## UNITARY PLAN UPDATE REQUEST MEMORANDUM

**Kiwirail Holdings Ltd Designation 6302 North Island Main Trunk Railway Line from Buckland to Britomart Station, Auckland Central (adjacent to Middlemore station) in accordance with sections 279(1)(b) and 172 of the Resource Management Act (RMA)**

**CONSENT ORDER**

## **Appendix A: Conditions to Designation 6302**

**W2QP**  
 WO -  
 MIDDLEMORE  
 DESIGNATION PLAN

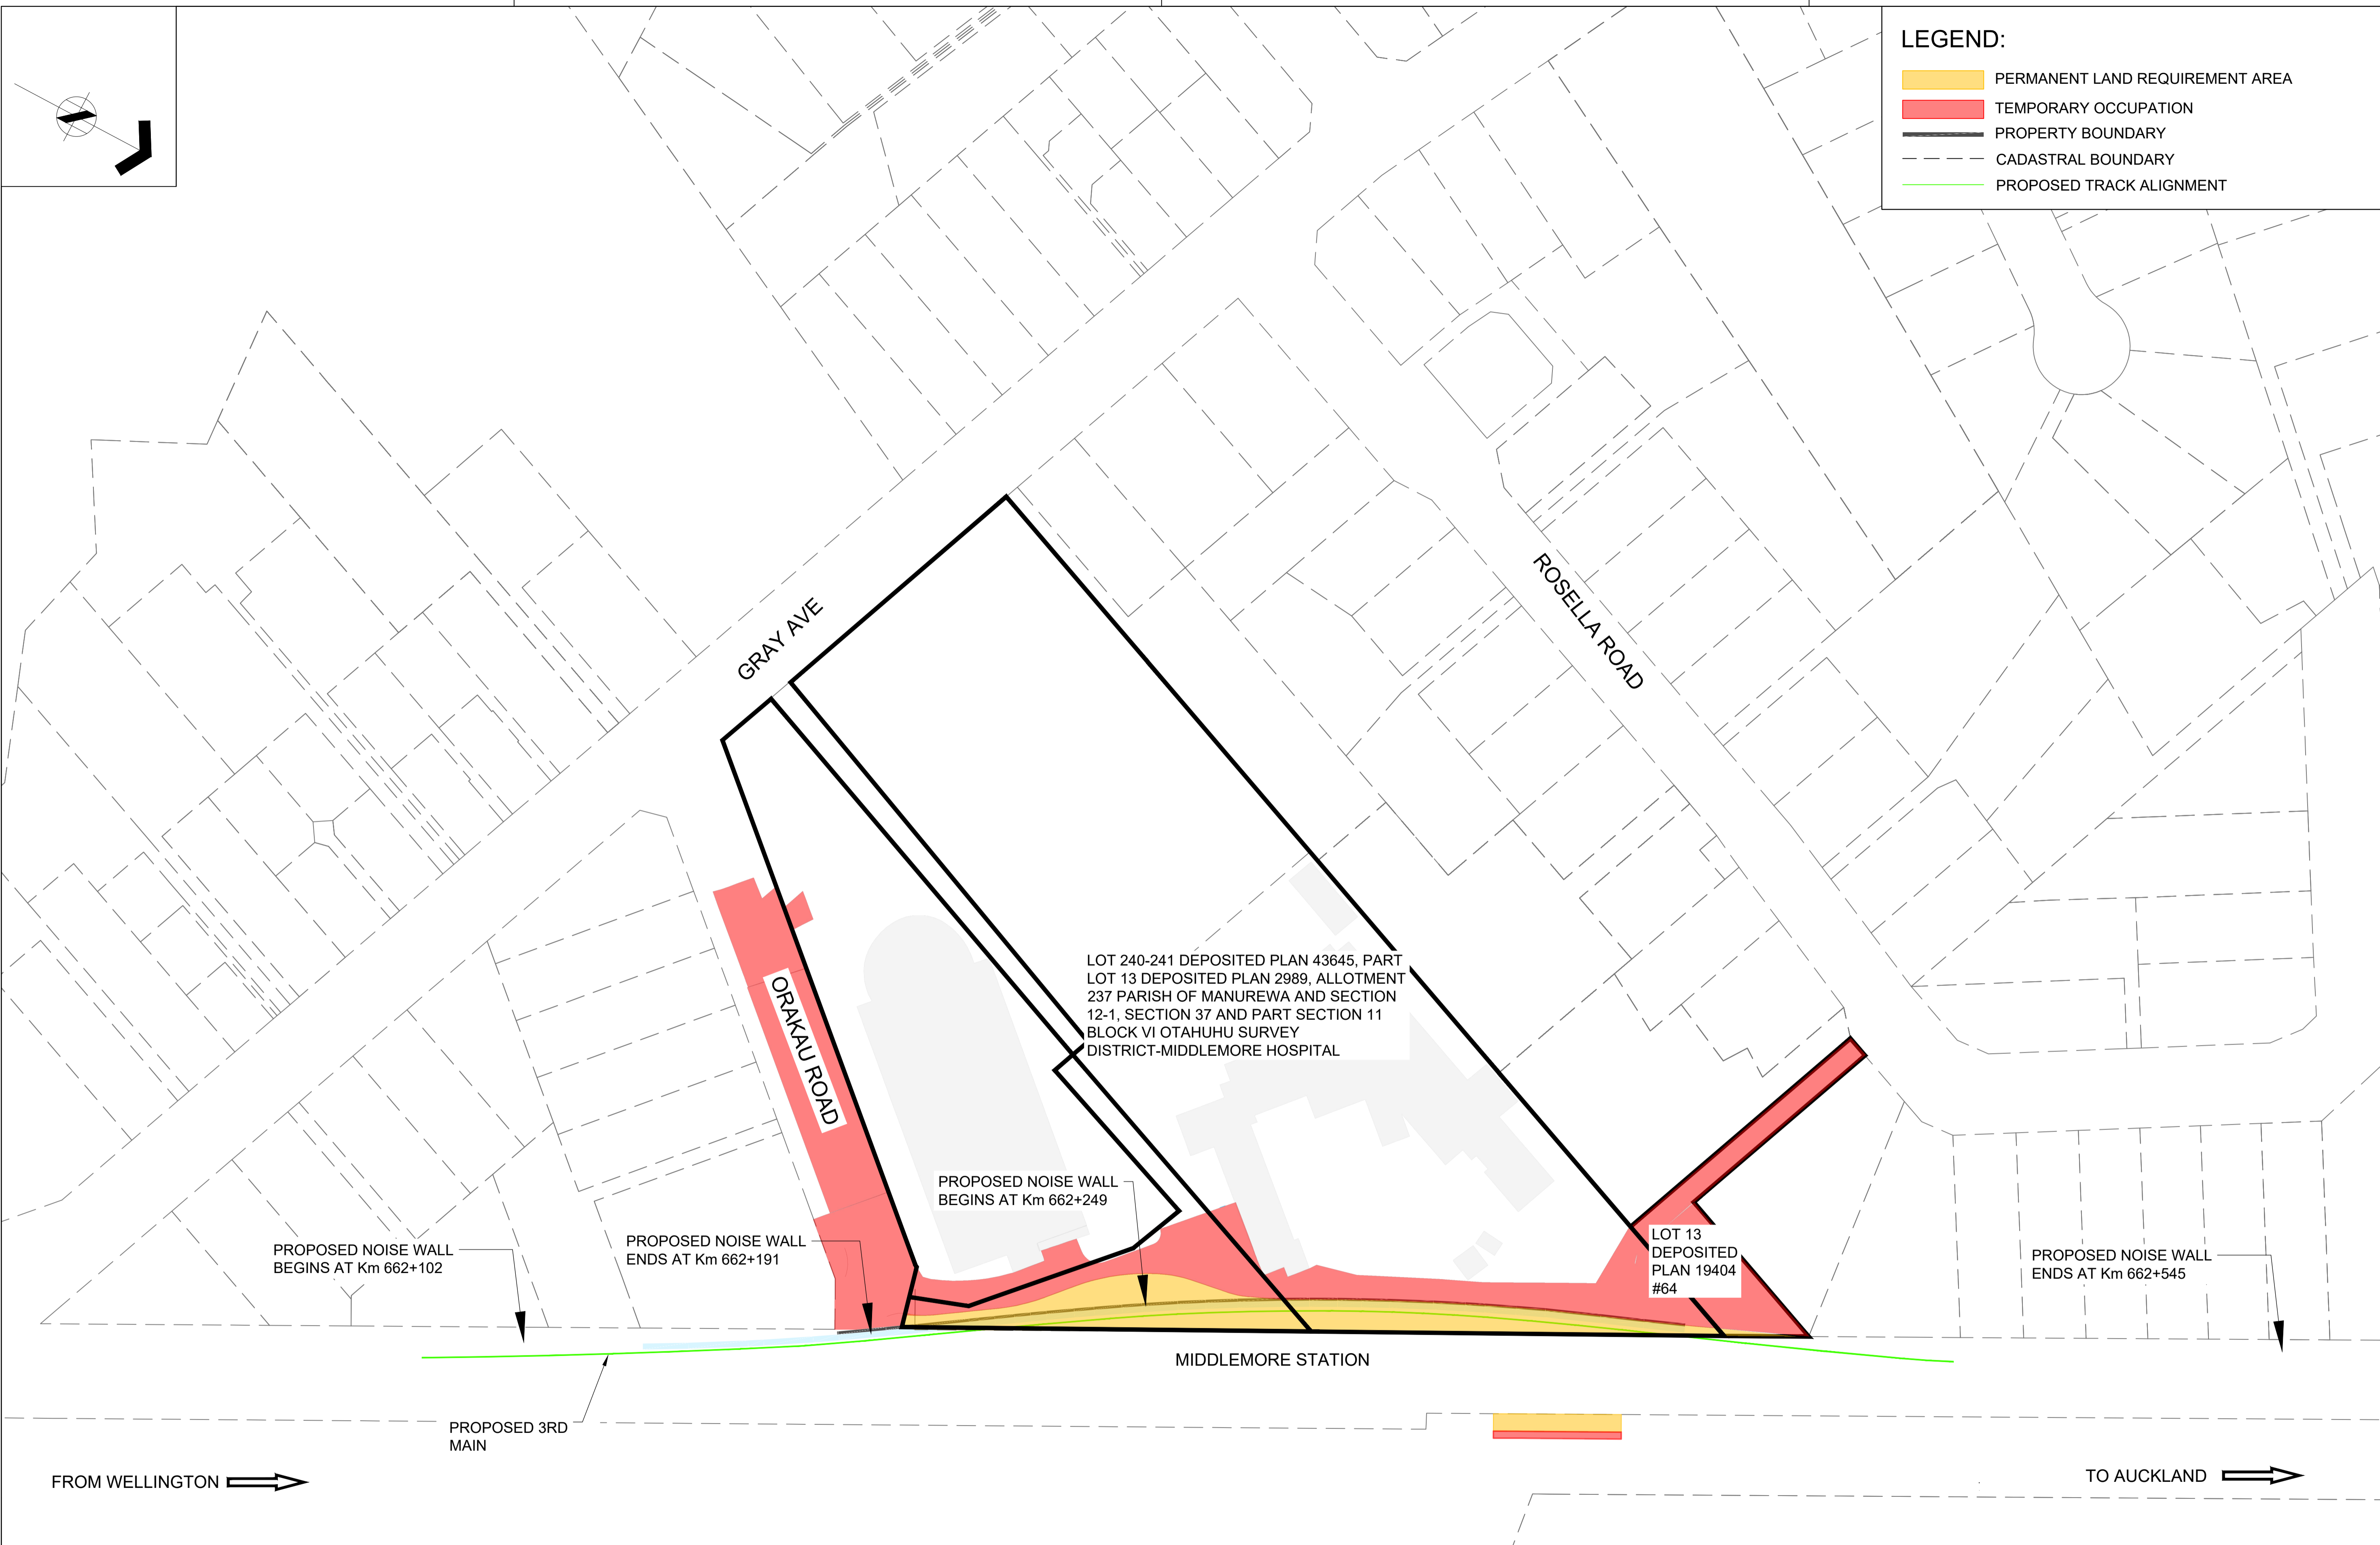
[18] The key modifications to the NoR extent now proposed reflect an operational requirement by Te Whatu Ora for the hospital's pedestrian crossing to be located on its landholdings closer to the Te Whatu Ora multi-storey carpark on its western campus. As a result, KiwiRail has agreed to relocate the Middlemore Station pedestrian overbridge and lift facility.

- (a) update the land requirement plan for Middlemore in condition 7 to reflect the modification described at [18] above;
- (b) update conditions 22 and 23 to enable alternative vibration mitigation measures to provide operational flexibility for KiwiRail while also meeting the levels of mitigation required. The parties have advised that there are a variety of potential vibration mitigation measures that may be employed for this Project and, with the potential for technological improvements over time, it is important that the Project is not unduly restricted where it can meet the required levels of mitigation;

- drawing entitled "[W2QP WO - Middlemore Designation Station Land Requirement Layout Plan](#)", [Drawing No. DR3, Revision 0.2 Reference DR-NIMT-CV-HS-00179 and dated 16 December 2021](#); and

- drawing entitled "W2QP WO - Middlemore Designation Plan", Drawing No. DR3, Revision 0.2; and
  - drawing entitled "Wiri Junction Land Requirement Layout Plan (Sheet 2)", Reference DR-NIMT-CV-HS-00175 and dated 22 November 2021.

## Alteration to Designation 6302 KiwiRail

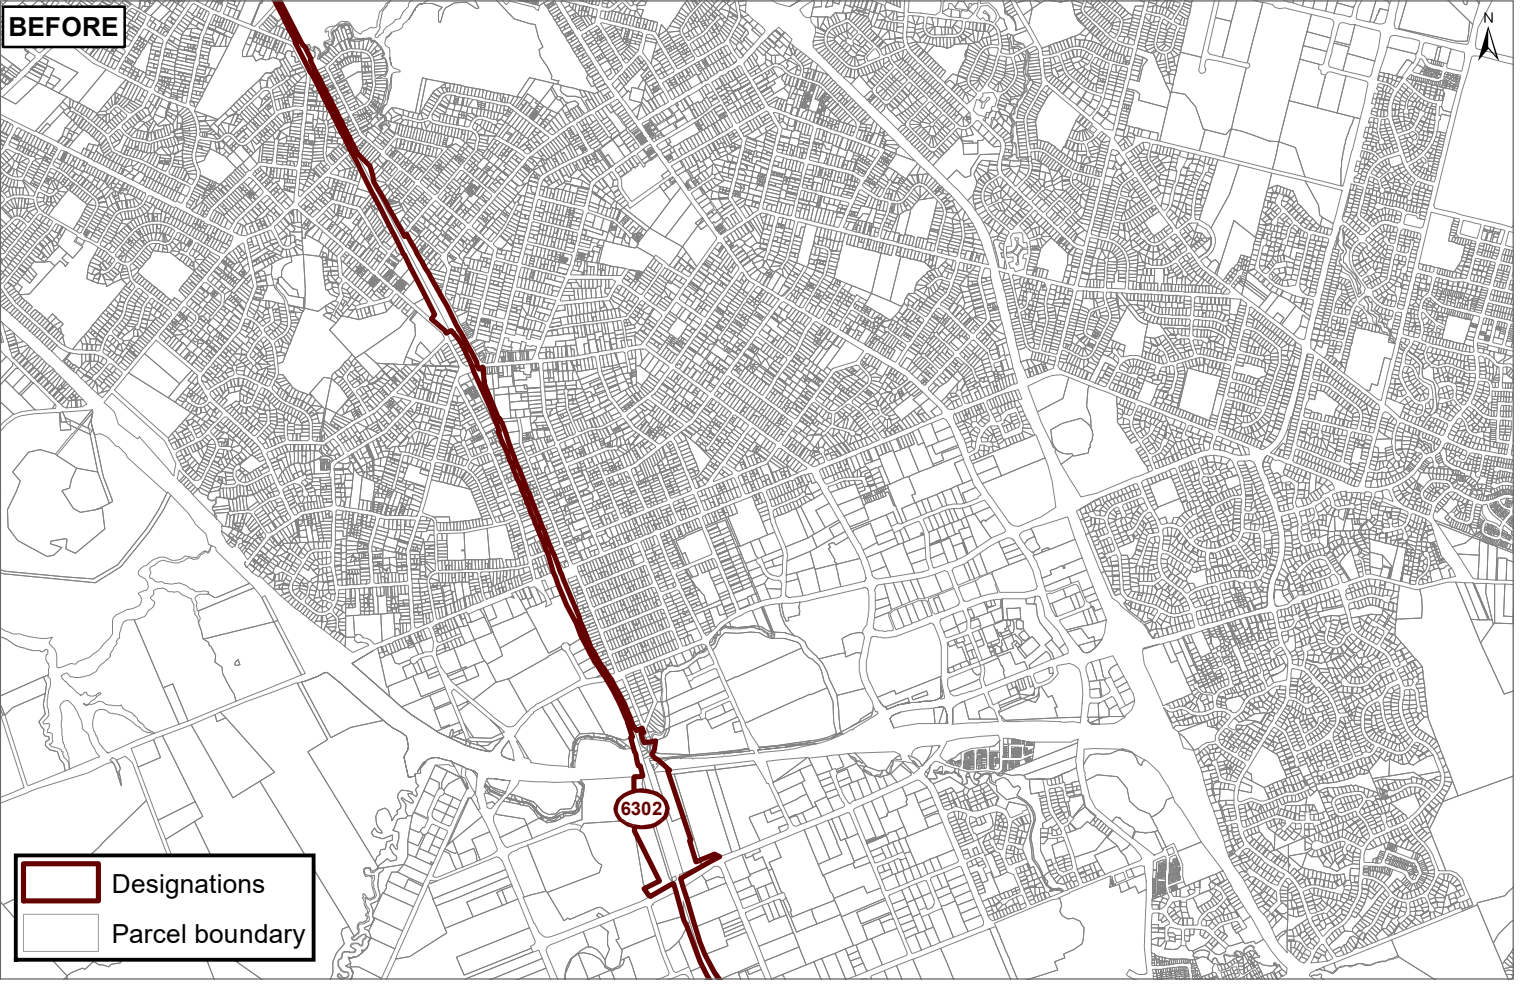
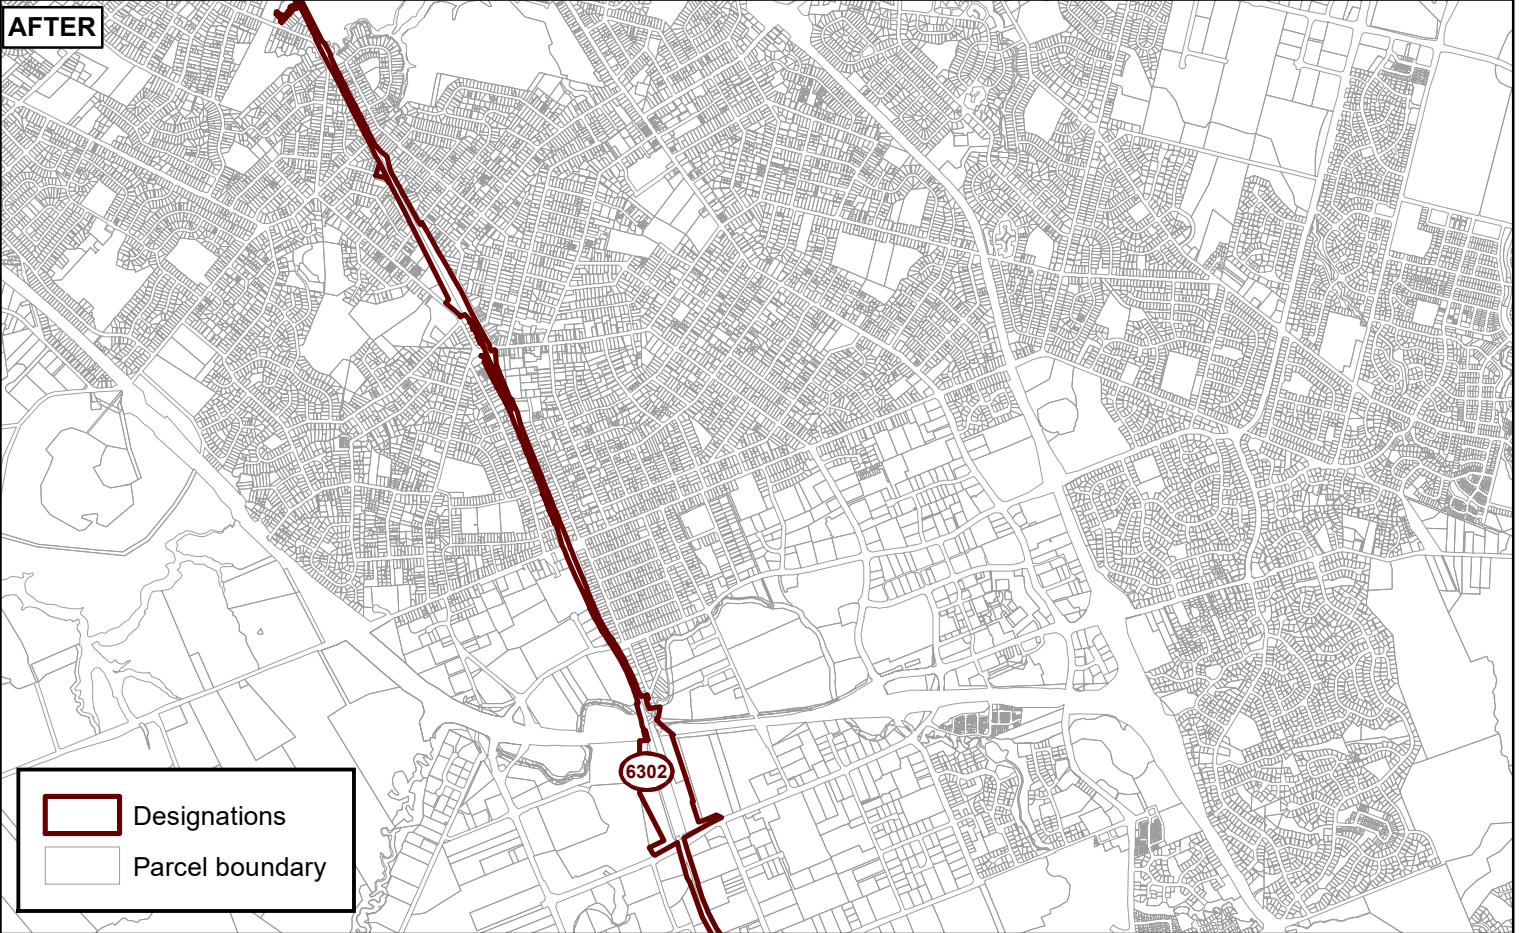
<b>Changes to text and diagrams (shown in underline and strikethrough)</b>	Include condition wording and diagrams as per those referred to below under 'Attachments'
<b>Changes to spatial data</b>	Include boundaries of designation 6302 in accordance with the Consent order Decision – Refer Attachment A to this memo.
<b>Attachments</b>	Attachment A: Consent Order Attachment B: Updated Text Attachment C: Updated GIS Viewer
